STAFF REPORT
COMMUNITY DEVELOPMENT DEPARTMENT

HEARING DATE: April 7, 2022
 TO: Planning & Zoning Commission
 FROM: Sonya Allen, Associate Planner
 208-884-5533
 SUBJECT: H-2022-0008 – Records Apartments
 LOCATION: Northeast corner of N. Records Way and E. Fairview Ave., in the SW 1/4 of Section 4, T.3N., R.1E (Parcel #S1104347005)

A. Site Plan (date: 1/20/2022)

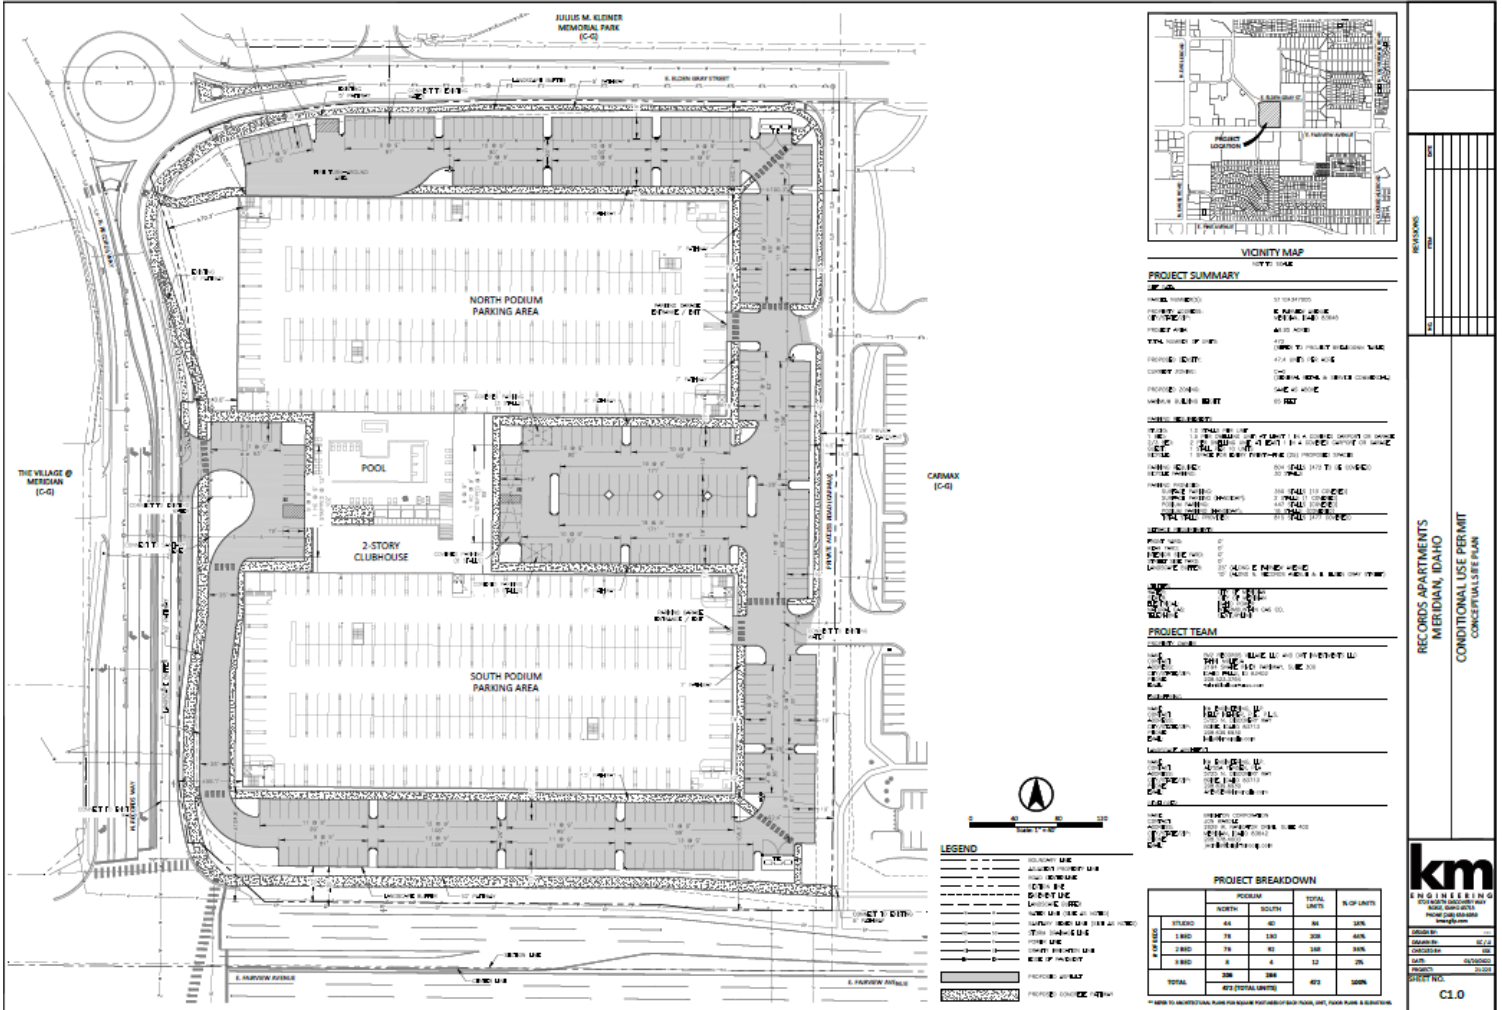
Landscaping is required within parking lots in accord with the standards listed in UDC 11-3B-8C. **The three (3) "diamond" planter islands between the north & south portions of the building do not meet the standards in UDC 11-3B-8C.2, which require planters to contain a minimum of 50 square feet and run the length of the parking space; the site/landscape plan should be revised accordingly. Where bumpers overhang perimeter landscaping in parking areas, the parking stall dimensions may be reduced 2' in length if 2' is added to the width of the landscaped area planted in groundcover; otherwise, wheel stops should be provided to prevent vehicle overhang. The perimeter buffers/parking along the south and east boundaries of the site should be revised to comply with this standard.**

- k. Remove the access driveway via N. Records Way in accord with UDC 11-3A-3A.1, unless otherwise waived by City Council.
 - l. The minimum width of parkways planted with Class II trees is 8-feet; the planter width may be reduced to 6-feet if there are root barriers that meet the standards in UDC 11-3A-17E.

- e. Remove the three (3) “diamond” planter islands between the north & south portions of the building and replace them with planter islands that comply with the standards in UDC [11-3B-8C.2](#).

B. Landscape Plan (dated: 1/20/22)

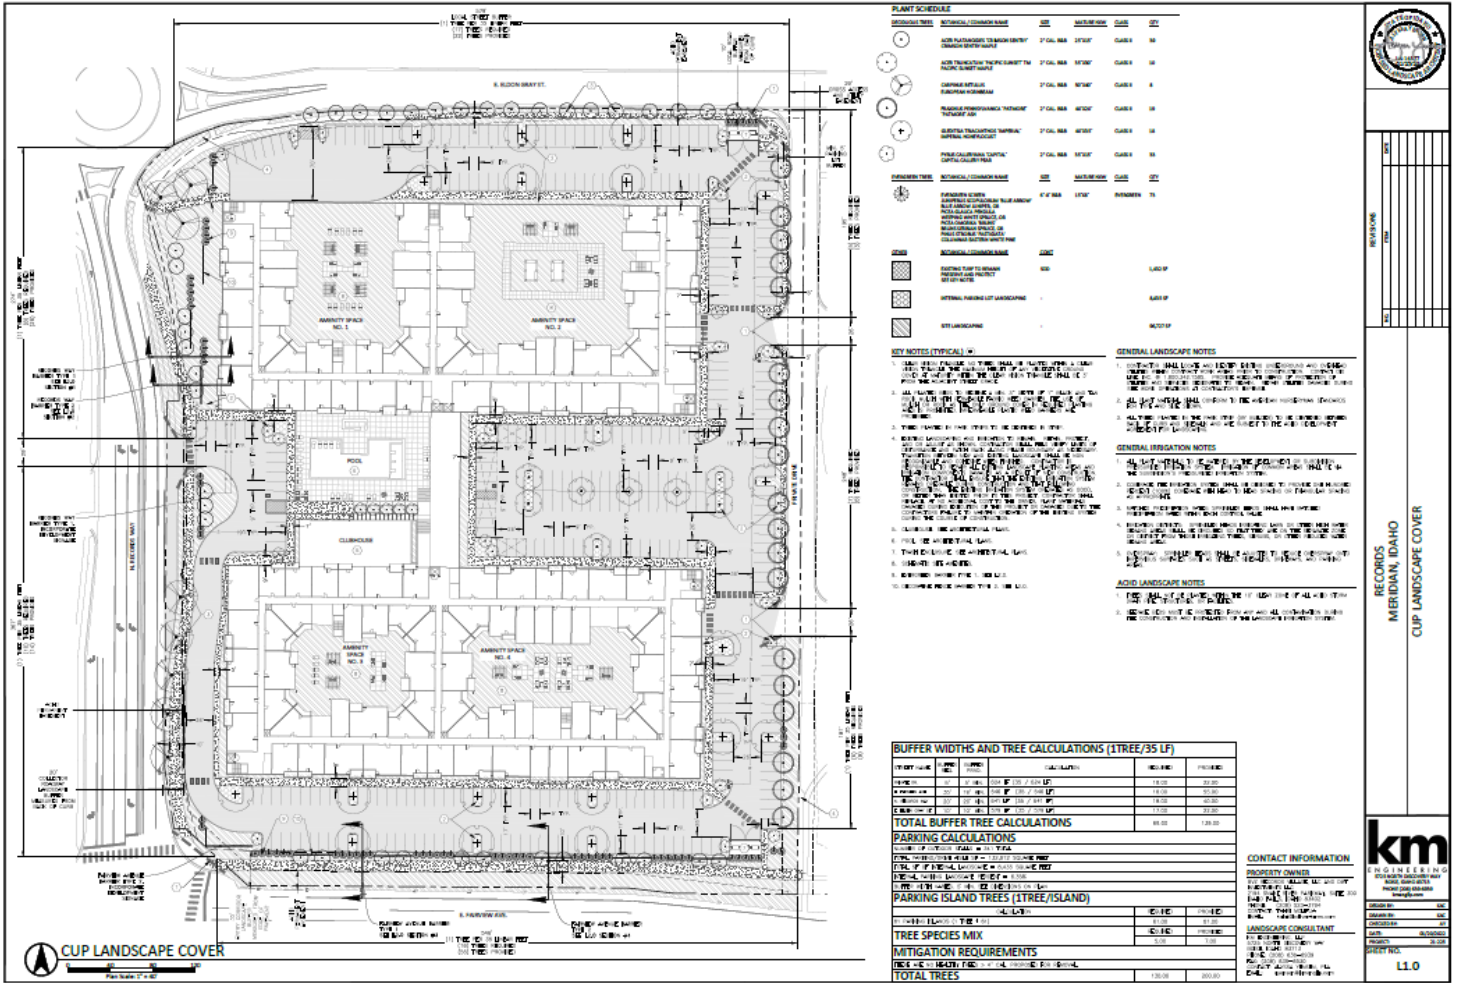
Landscaped street buffers are required to be provided as follows: a 35-foot wide street buffer is required along E. Fairview Ave., an entryway corridor; a 20-foot wide buffer is required along N. Records Way, a collector street; and a 10-foot wide buffer is required along E. Elden Gray St., a local street, per UDC Table 11-2B-3 and landscaped per the standards listed in UDC [11-3B-7C.3](#). **Some portions of the buffers along Records and Fairview are below the required widths and should be revised. All buffers are required to be planted with a variety of trees, shrubs, lawn or other vegetative groundcover and designed to elicit design principles including rhythm, repetition, balance and focal elements per the recently updated specifications; the landscape plan shall be revised accordingly.**

Landscaping is required to be provided along all pathways per the standards listed in UDC [11-3B-12C](#), which require a *mix* of trees, shrubs, lawn and/or other vegetative groundcover. **Shrubs should be added to the landscape plan in accord with this standard where none are depicted.**

- d. Within street buffers, depict a *variety* of trees, shrubs, lawn or other vegetative groundcover designed to elicit design principles including rhythm, repetition, balance and focal elements per the recently updated specifications set forth in UDC [11-3B-7C.3](#).

- f. Shrubs shall be added to the landscape strips along pathways where none currently exist in order to contribute to the *mix* of landscaping required by UDC [11-3B-12C.2](#).

C. Qualified Open Space (dated: 12/8/21, stamped on 1/25/22) **NOT APPROVED**

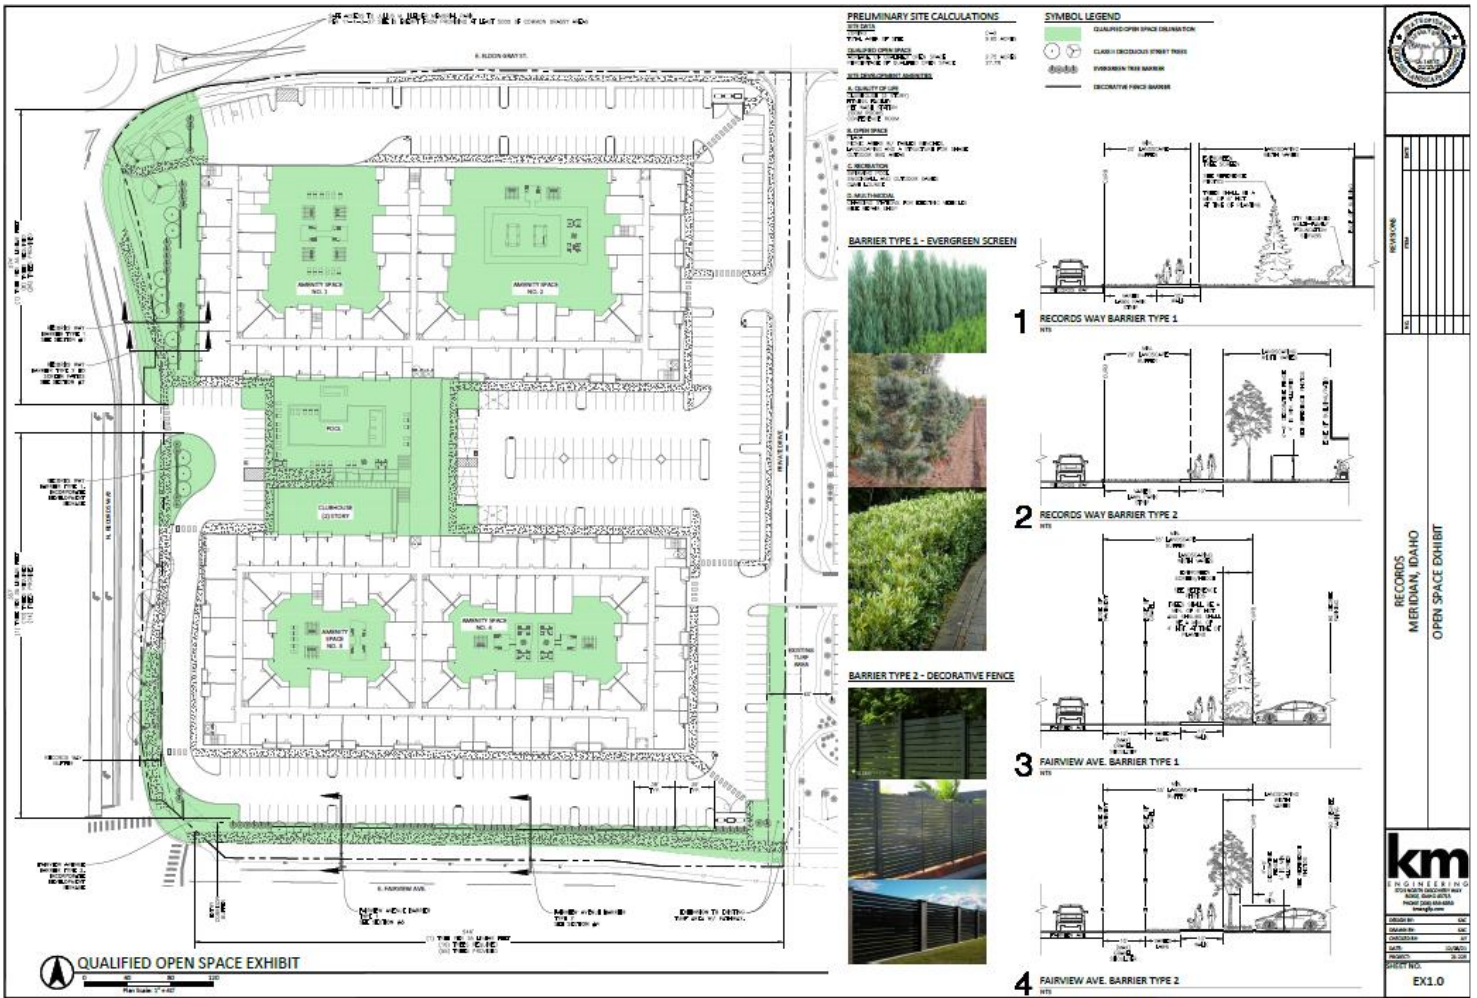
The open space exhibit in Section VIII.C depicts a total of 2.75 acres (or 27.7%) of common open space for the development consisting of four (4) internal amenity spaces, the clubhouse and swimming pool area, street buffers along Records (a collector street) and Fairview (an arterial street), and buffer along the southern portion of the east boundary of the site. Per UDC 11-4-3-27C.5, common open space areas shall not be less than 400 square feet in area, and shall have a minimum length and width dimension of 20 feet. **The buffer along the southern portion of the east boundary of the site and the southern portion of the street buffer along N. Records Way is below 20 feet in width and does not meet this standard.** Per UDC 11-4-3-27C.7, unless otherwise approved through the conditional use process, common open space areas shall not be adjacent to collector or arterial streets unless separated from the street by a berm or constructed barrier at least four feet (4') in height, with breaks in the berm or barrier to allow for pedestrian access. **The buffers along Records and Fairview are not separated from the street by a berm and do not meet this standard. Staff recommends a revised open space exhibit is submitted that provides a minimum of 3.74 acres of qualified open space meeting the minimum standards noted above and in UDC 11-4-3-27C prior to the Commission acting on this application. The reduction in the number of units as recommended may result in extra area for common open space to be provided meeting the minimum standards.**

- m. Depict common open space that complies with the dimensional standards in UDC 11-4-3-27 (i.e. shall not be less than 400 square feet in area and shall have a minimum length and width dimension of 20 feet).
